**Rezoning Application:** PD 23-0109  
**Zoning Hearing Master Date:** September 18, 2023  
**BOCC Land Use Meeting Date:** November 7, 2023

**1.0 APPLICATION SUMMARY**

## AGENCY REVIEW COMMENT SHEET

PETITION NO: RZ 23-0109

### 2.4 Proposed Site Plan (partial provided below for size and orientation purposes. See Section 8.0 for full site plan)

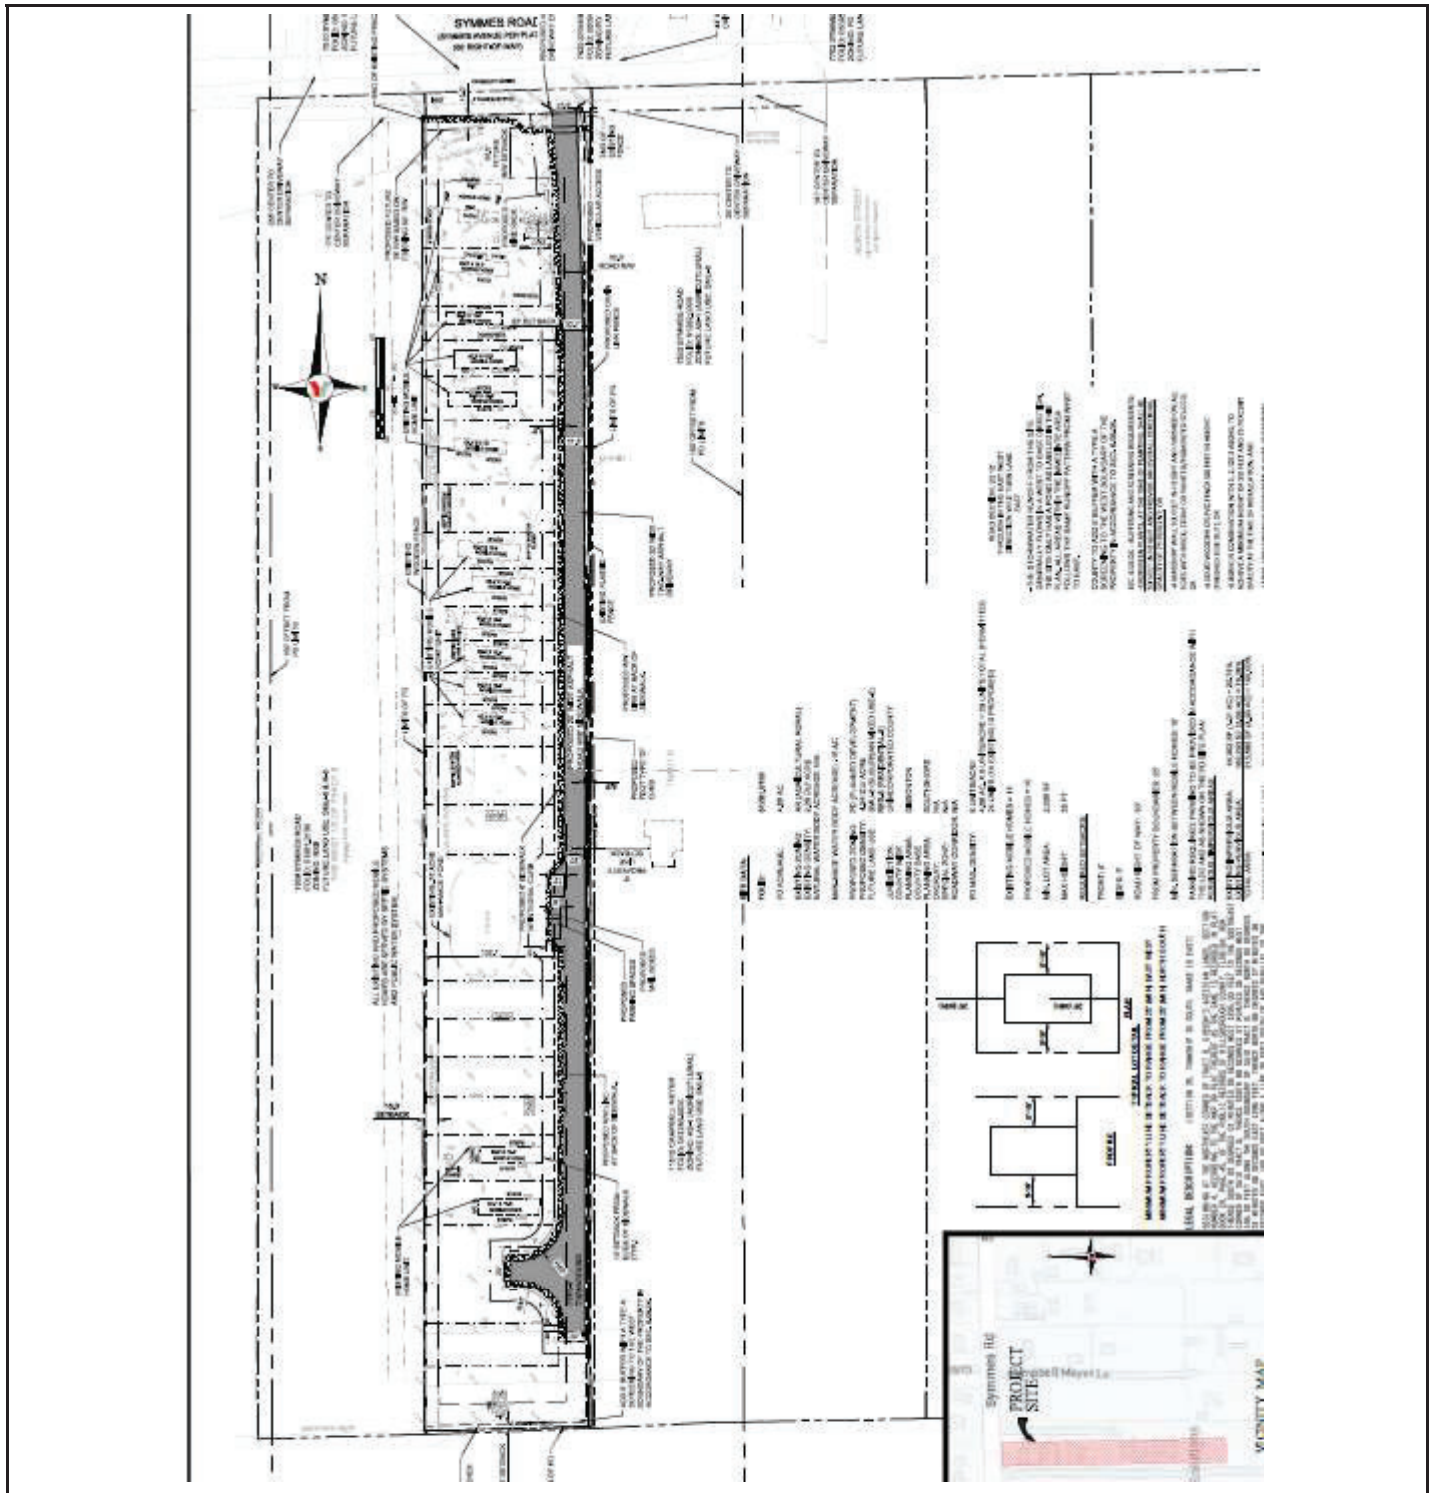
Prior to site plan certification, the applicant shall revise the PD site plan to:

1. Show the portions of the property located within the coastal high hazard area;
2. Remove the RES-6 future land use designation from the site data table;
3. Revise label which reads "Proposed Future 76' R/W Based on Existing 50' R/W" to instead read "+/- 13-Foot-Wide Right-of-Way Preservation Area per Hillsborough County Corridor Preservation Plan";
4. Revise the PD zoning to delete all sheets except the first sheet. Staff notes that the other 2 sheets appear to be duplicative and serve no regulatory purpose; and
5. Revise the Site Data Table to change "Proposed Mobile Homes = 10" to instead read "Proposed Mobile Homes = 24". If the applicant wishes, they can add a new line above the "Proposed Mobile Homes" line which states "Additional Mobile Homes = 10"; however, this is not required.

Sunshine Acres, Zoning Case # 23-0109  
September 5, 2023

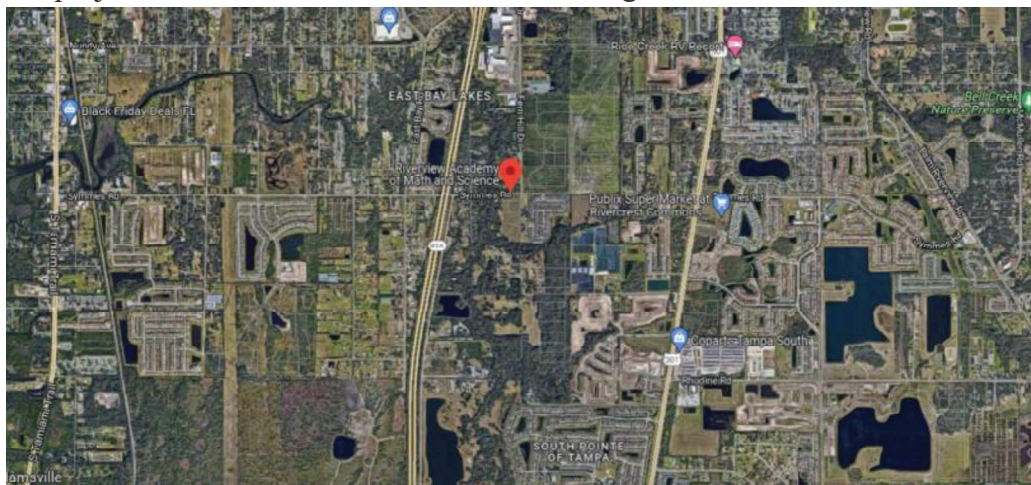
1. A variance of +/- 294 feet from the closest driveway to the east on the same (south) side of the roadway. If approved, this would result in an access spacing of +/- 36 ft.
2. A variance of +/- 155 feet from the closest driveway to the west on the same (south) side of the roadway. If approved, this would result in an access spacing of +/- 175 ft.
3. A variance of +/- 286 feet from the closest driveway to the east on the opposite (north) side of the roadway. If approved, this would result in an access spacing of +/- 44 ft.
4. A variance of +/- 235 feet from the closest driveway to the west on the opposite (north) side of the roadway. If approved, this would result in an access spacing of +/- 95 ft.

Refer to attached proposed site plan showing distances between driveways.

**SUNSHINE ACRES 7515 SYMMES RD**  
GENERAL DEVELOPMENT PLAN  
SECTION 35, TOWNSHIP 30S, RANGE 19E.

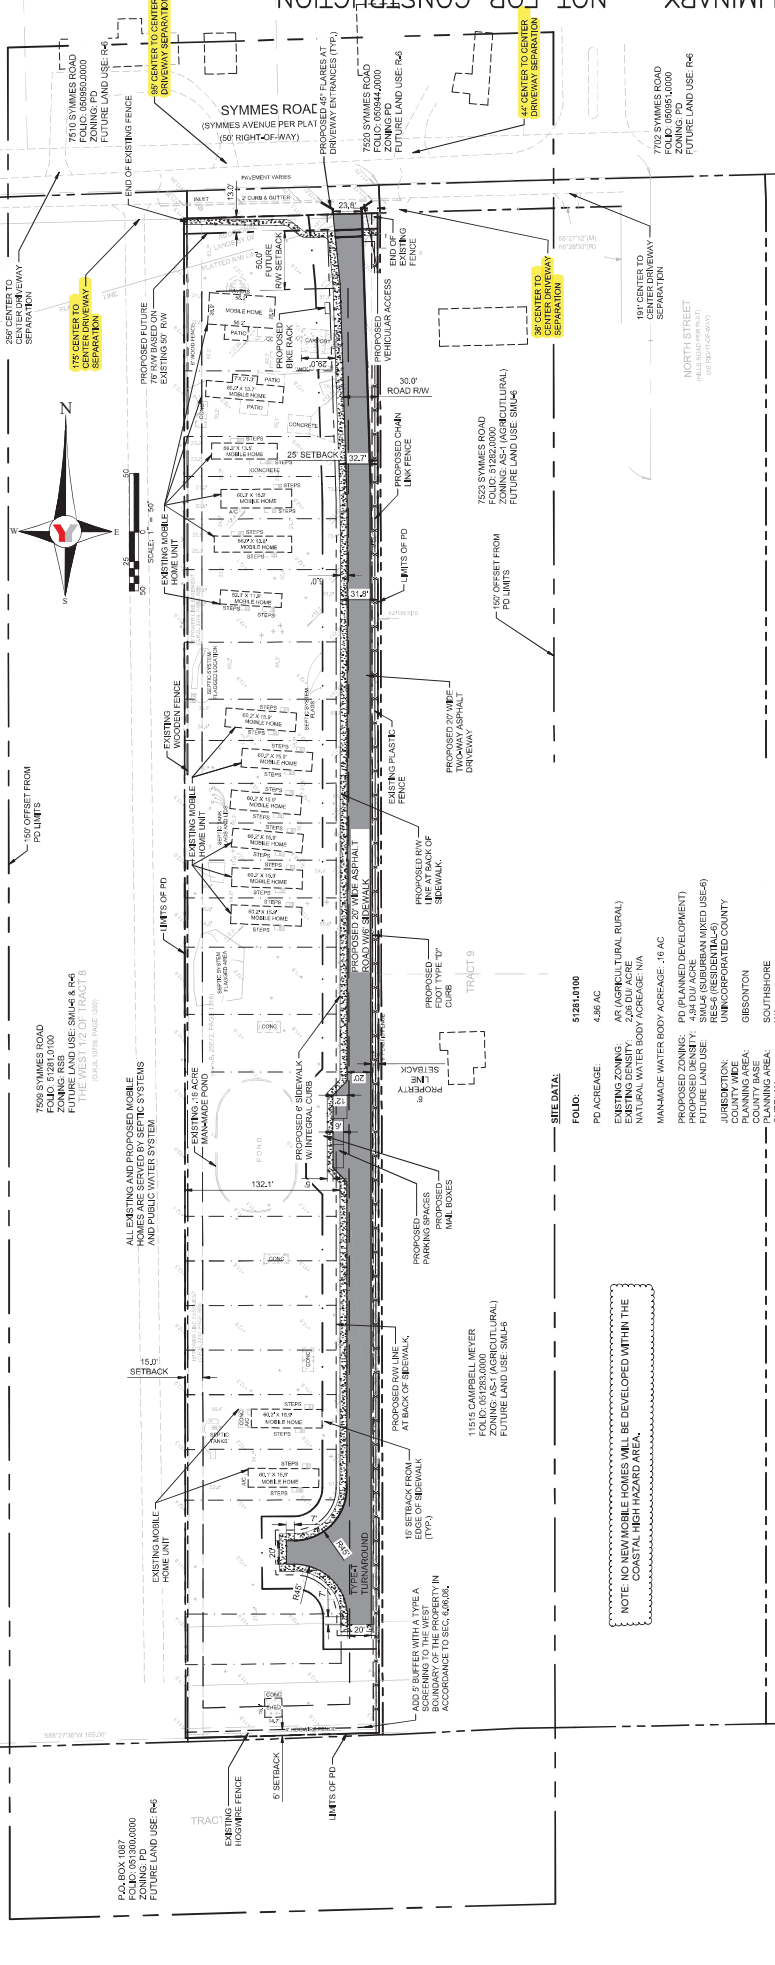
- Prior to PD site plan certification, the applicant shall revise the PD site plan to:
  - Revise label which reads “Proposed Future 76’ R/W Based on Existing 50’ R/W” to instead read “+/- 13-Foot-Wide Right-of-Way Preservation Area per Hillsborough County Corridor Preservation Plan”;
  - Revise the PD zoning to delete all sheets except the first sheet. Staff notes that the other 2 sheets appear to be duplicative and serve no regulatory purpose.
  - Revise the Site Data Table to change “Proposed Mobile Homes = 10” to instead read “Proposed Mobile Homes = 24”. If the applicant wishes, they can add a new line above the “Proposed Mobile Homes” line which states “Additional Mobile Homes = 10”; however, this is not required.
